Product Change Notification #10052

Notification of: Increased Standoffs from 1 to 4 on the termination side of the male header.

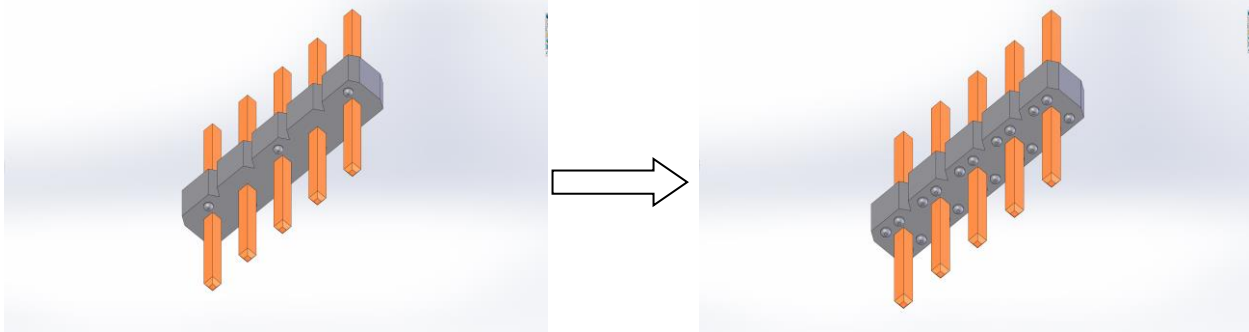
Explanation of change (from, to):

Reason for change: Improvement on the 1 & 2 positions (cut) header sit flat on the PCB.

Anticipated impact on fit, form, or function (positive/negative): Positive.
